METROPOLITAN GOVERNMENT OF NASHVILLE AND DAVIDSON COUNTY

STAFF RECOMMENDATION
800 Setliff Place
July 15, 2015

Application: New construction--addition
District: Eastwood Neighborhood Conservation Zoning Overlay
Council District: 06
Map and Parcel Number: 08306005800
Applicant: Paul John Boulifard
Project Lead: Paul Hoffman, paul.hoffman@nashville.gov

<p>Description of Project: An application for a ridge raise and addition to the rear and side of the house.</p> <p>Recommendation Summary: Staff recommends approval with the conditions:</p> <ol style="list-style-type: none"> 1. Staff approve the final details, dimensions and materials of windows and doors prior to purchase and installation; 2. HVAC and other utilities should be located so as to minimize visibility from the street-facing facades; and, 3. Staff approve the roof color and masonry color, dimensions and texture. <p>Staff finds the project meets the design guidelines for the Eastwood Neighborhood Conservation Zoning Overlay.</p> <p>The Commission does not have the authority to approve the use. This recommendation is for the design of the building based on the proposed use.</p>	<p>Attachments A: Photographs B: Site Plan C:

Figure 1. 800 Setliff Place

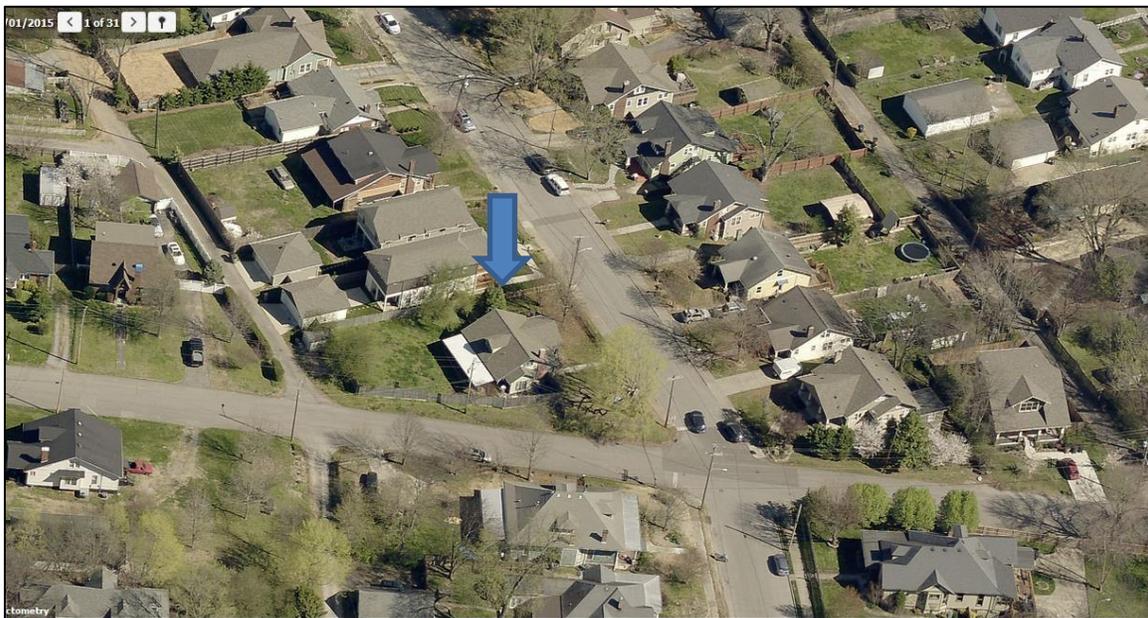
Background: 800 Setliff Place is a bungalow constructed circa 1927. It is a contributing building in the Eastwood district.

Analysis and Findings: The application is for a ridge raise and dormer to the rear of the house, and a side addition.

Partial Demolition: The scope of work includes the removal of most of the rear roof plane, including an existing rear dormer. The existing rear porch is not original to the house and will also be demolished. Eight feet (8') of the rear wall on both the rear and the right side will be removed for the additions. Two existing window openings will be removed for the addition, one on the right side where the addition will connect, and one on the rear. These windows will be reused in the new construction. The proposed partial demolition does not impact the architectural integrity of the house or the district, and the project meets Section III.B.2 for appropriate demolition and does not meet section III.B.1 for inappropriate demolition.

Figure 3. Side elevation of the addition and ridge raise.

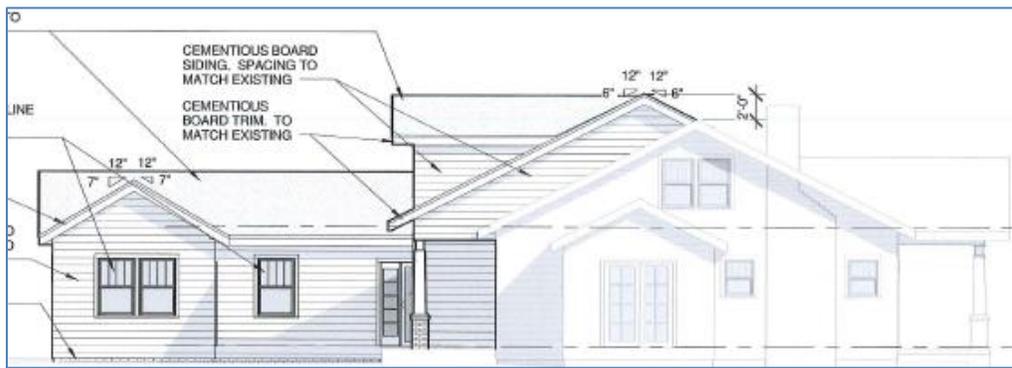
Height & Scale: The second story addition will add two feet (2') to the height of the house. The side addition is one story and will connect to the right side of the house around an existing window opening. The added footprint will be approximately nine hundred and twenty-three square feet (923 sq. ft.) to the existing one thousand, four hundred and sixty-two square feet (1,462 sq. ft.). The side addition is four feet (4') shorter than the existing ridge of the house, and less than half the width of the house. Staff finds the height and scale of the addition to be compatible with surrounding buildings and meets sections II.B.1 a and b for height and scale.

Design, Location & Removability: Although side additions are generally discouraged, the design guidelines allows for them in some instances, such as wide lots like this one that is one hundred and seven feet (107') wide at the street. In addition the lot narrows at the back making a more traditional addition, fully tucked in at the rear, problematic.

When side additions are appropriate they should be subordinate. The proposed does not wrap the rear corner, thereby altering the original form of the house. The front wall of the addition sits back past the midpoint of the house and is four feet (4') shorter than the historic home. The front wall of the addition is eighteen feet (18') wide compared to the original width of the house which is approximately forty feet (40'). Staff finds the size and shape of the lot warrants the side addition and that it is appropriately scaled.

① SITE PLAN
1/16" = 1'-0"

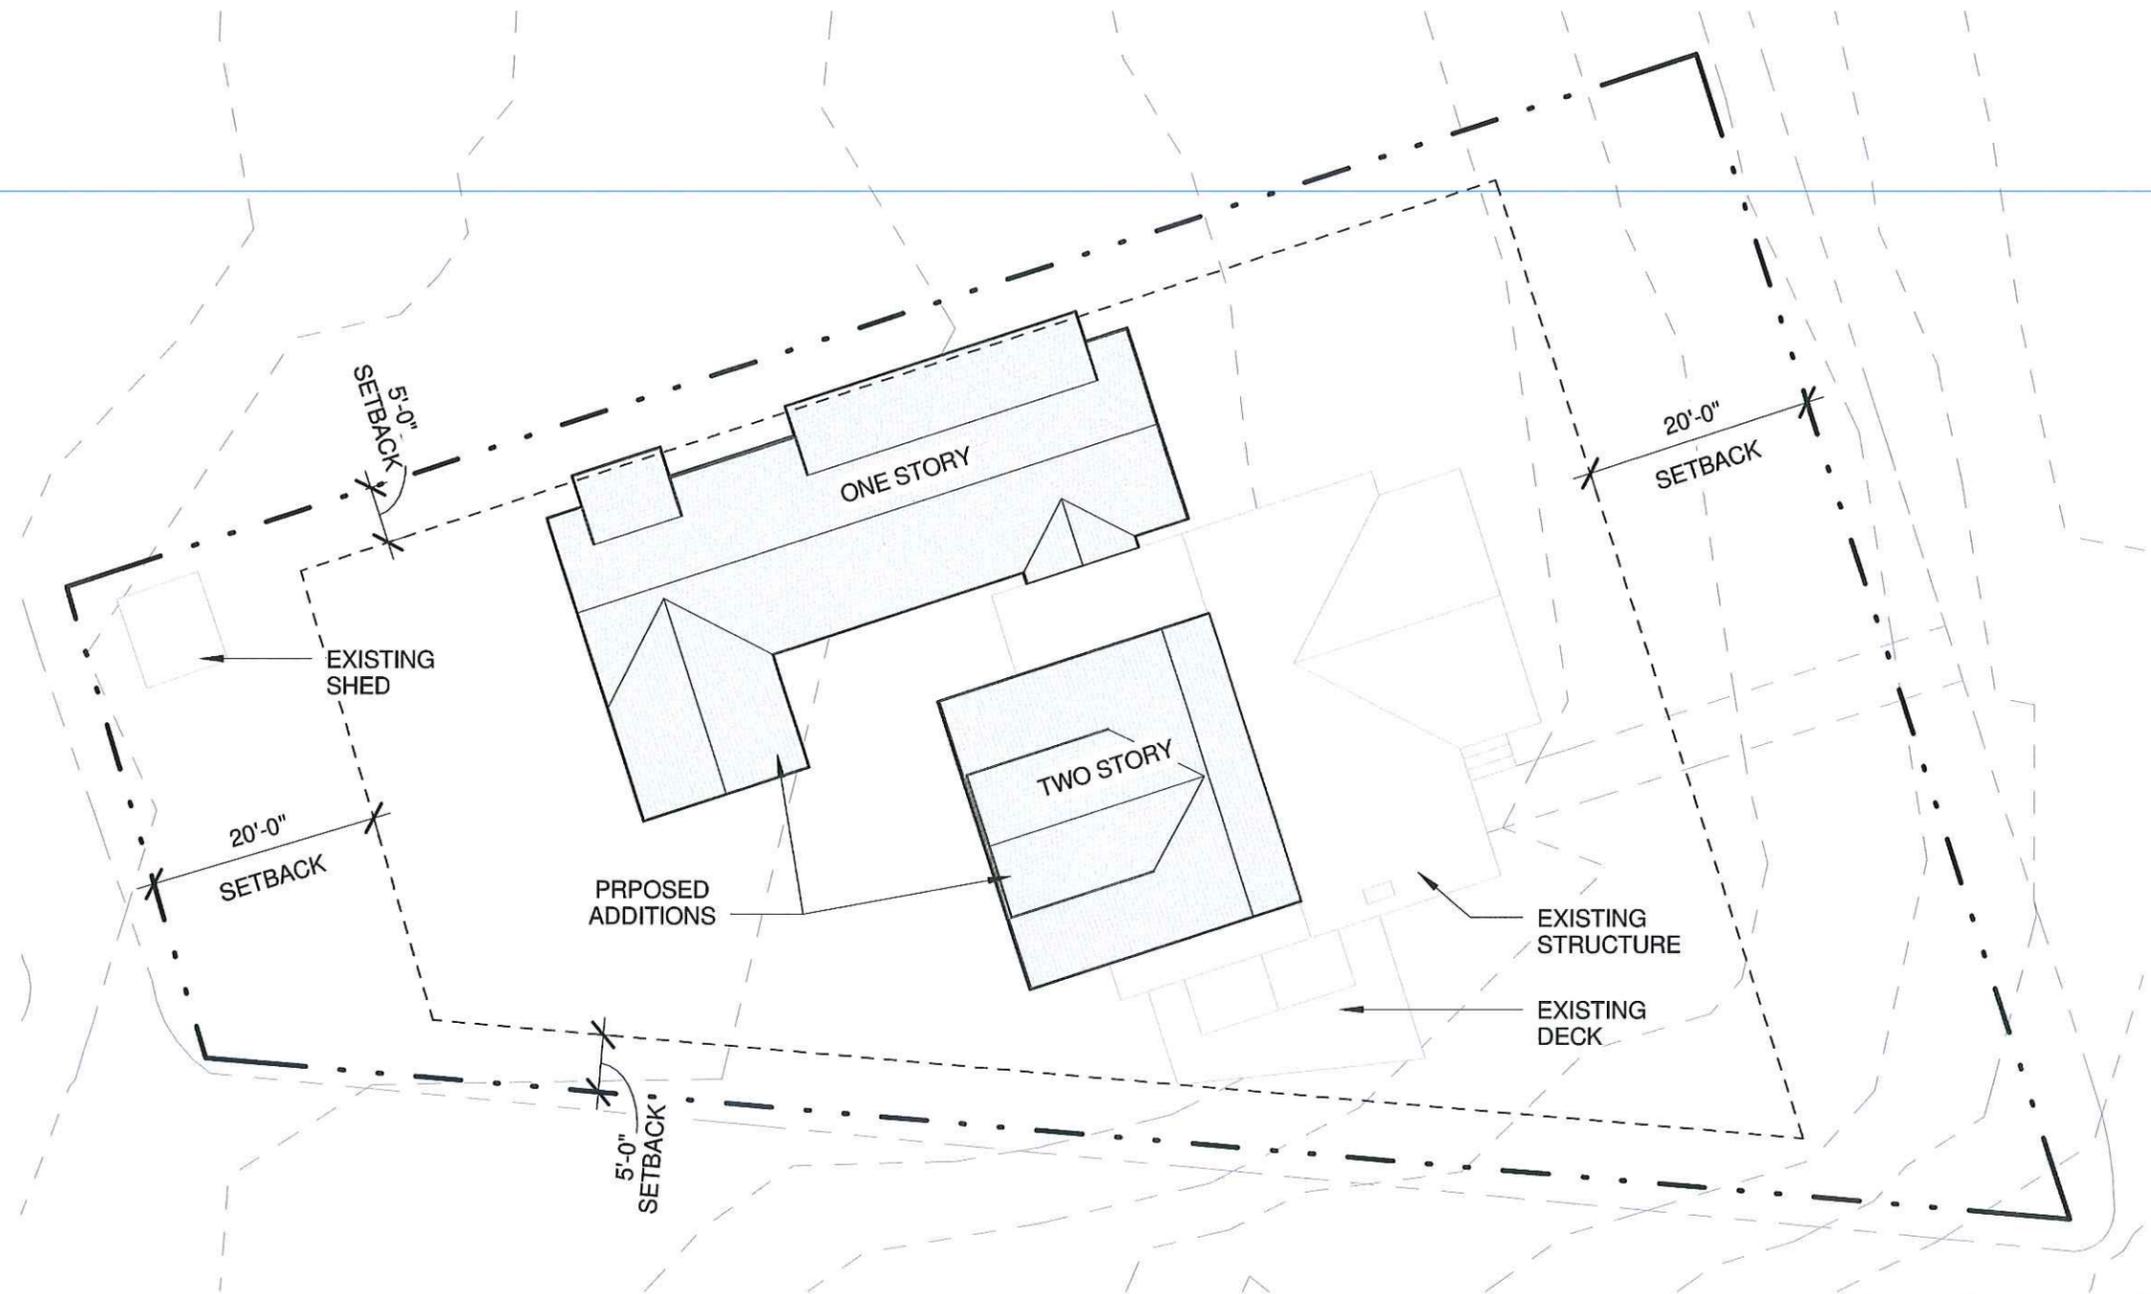
Setback & Rhythm of Spacing: The setbacks are five feet (5') and sixteen feet (16') on the sides and fifty feet (50') at the rear. The proposal meets base setback requirements of five feet (5') on the sides and twenty feet (20') at the rear. The project meets section II.B.1.c.

① ROOF LEVEL- PROPOSED
 1/8" = 1'-0"

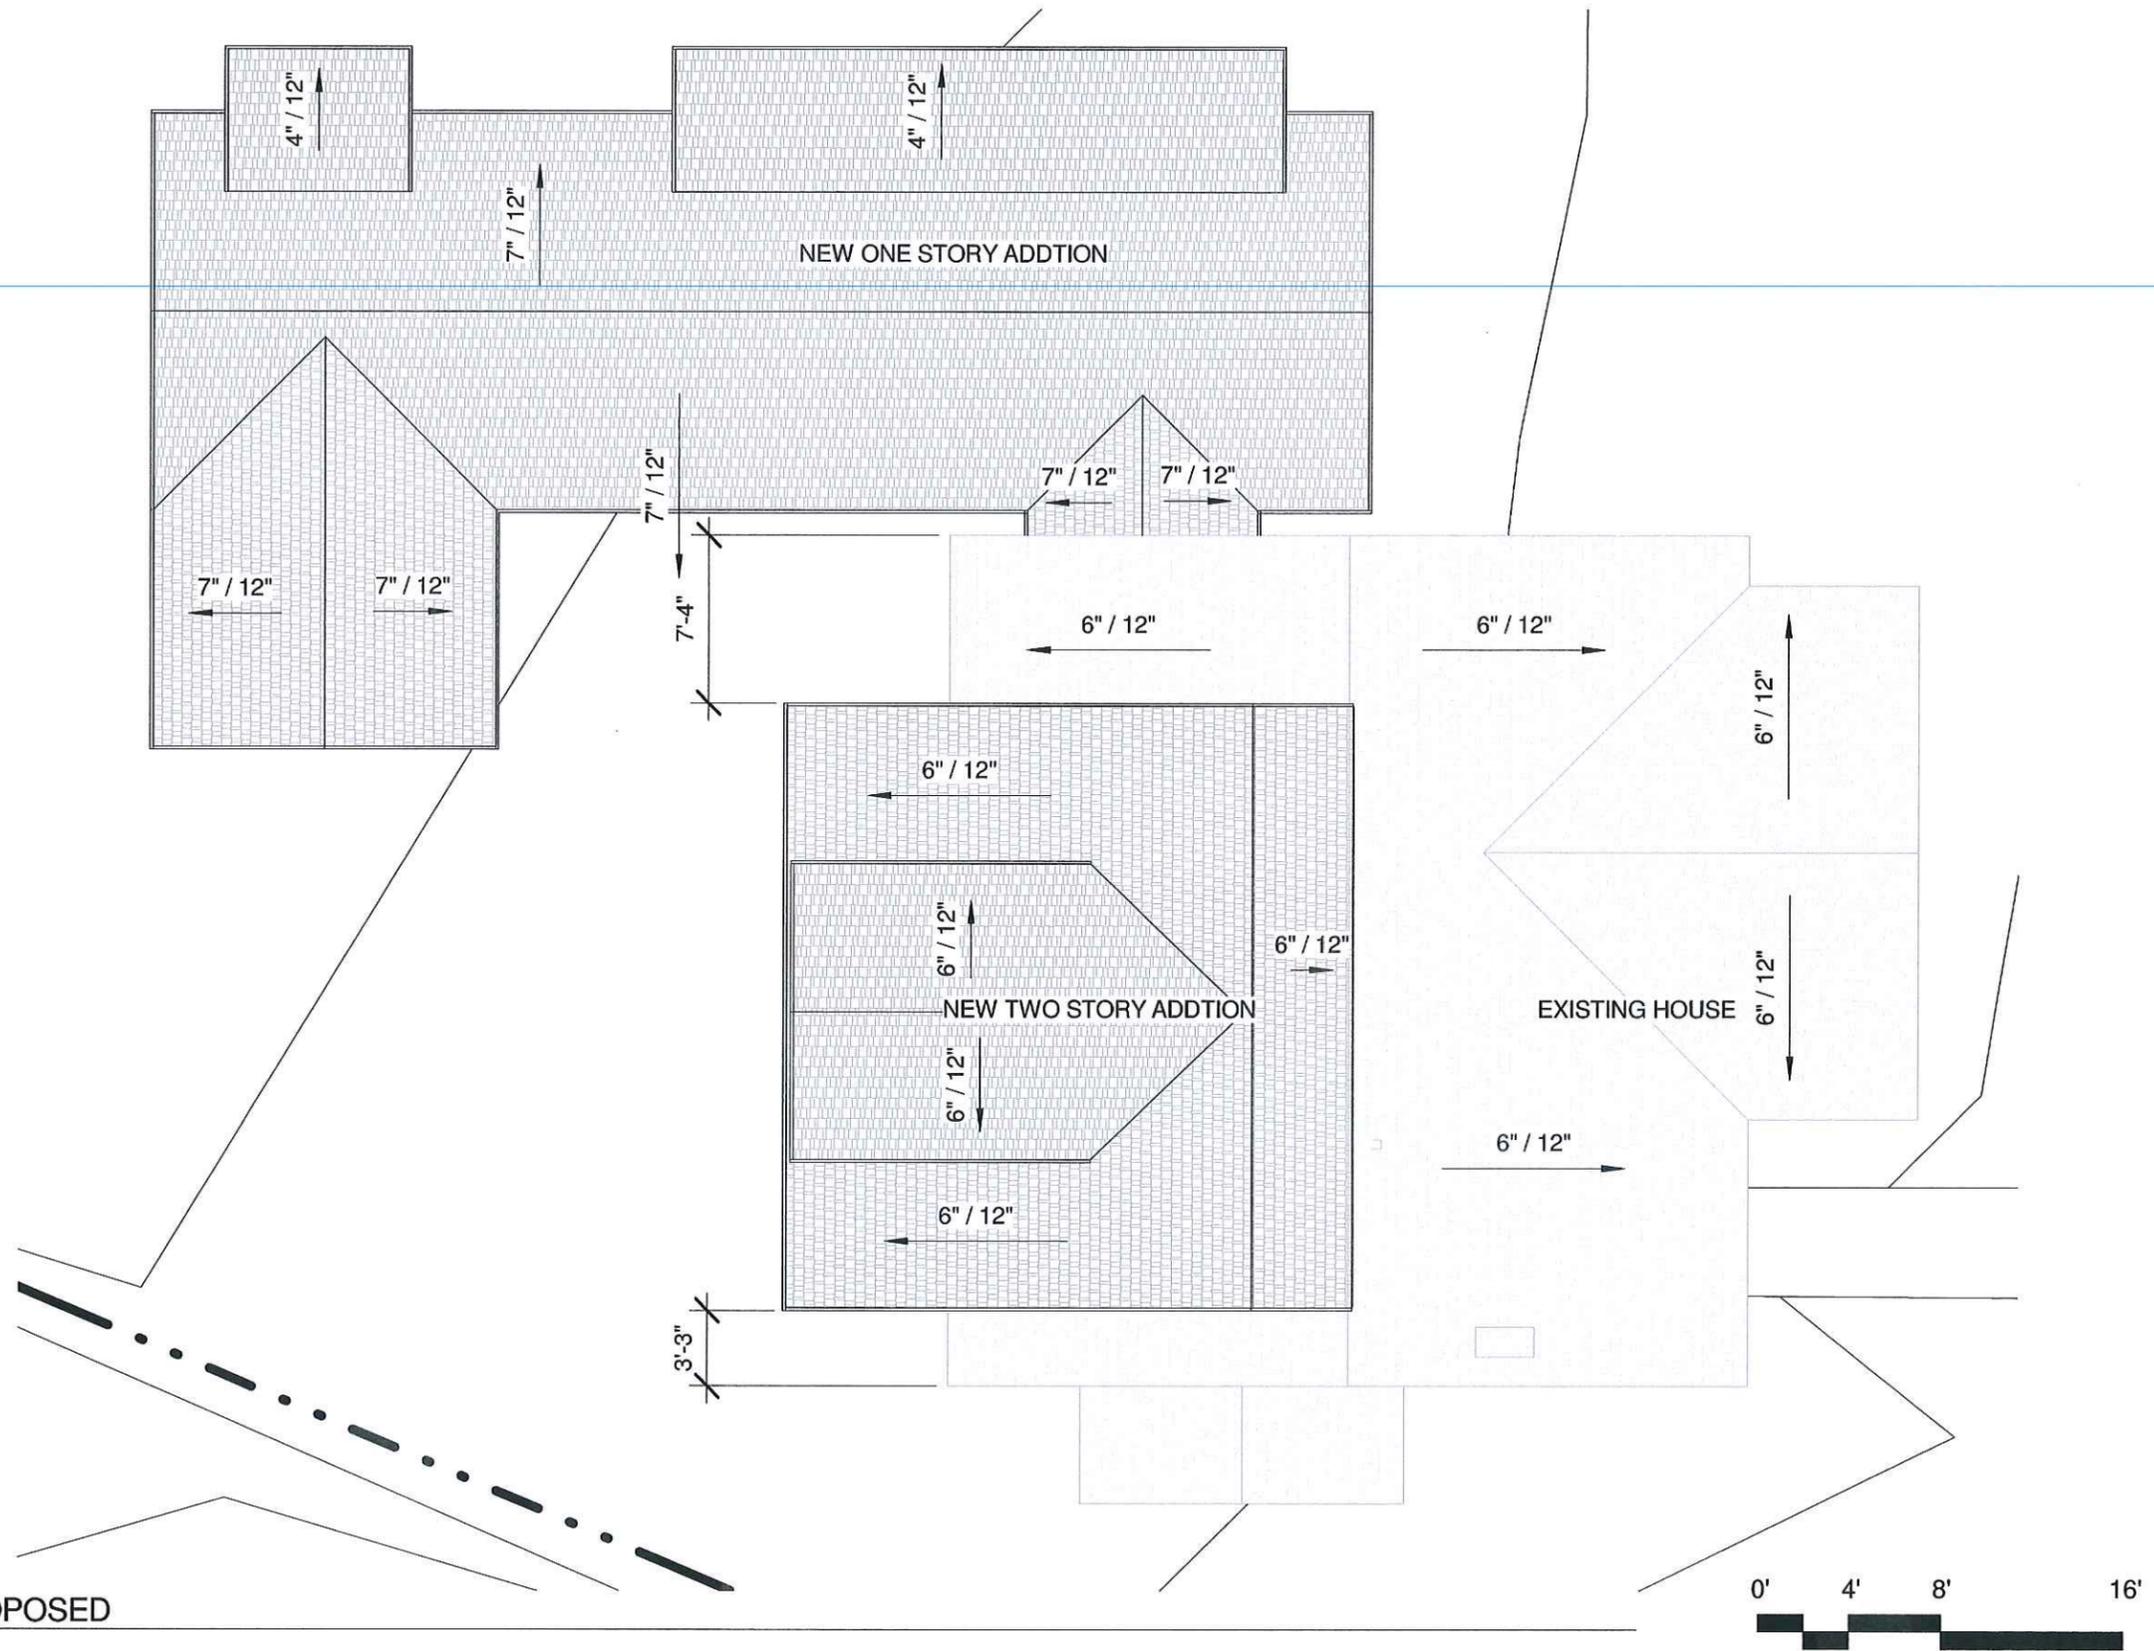
Roof form: The ridge of the house will be raised in conjunction with the addition. The ridge raise has insets of two feet (2') on the left side, and six feet (6') on the right. The two feet (2') added height meets the design guidelines. The second-story addition will have a shed roof with 6/12 pitch to the rear of the ridge raise. The gabled dormer is also 6/12 pitch. The side addition is gabled with 7/12 pitch. The roof forms and pitches on the project are compatible with the context, and meet section II.B.1.e.

1. Staff approve the final details, dimensions and materials of windows and doors prior to purchase and installation;
2. HVAC units and other utilities should be located to minimize their visibility from the street; and,
3. Staff approve the roof color and masonry color, dimensions and texture.
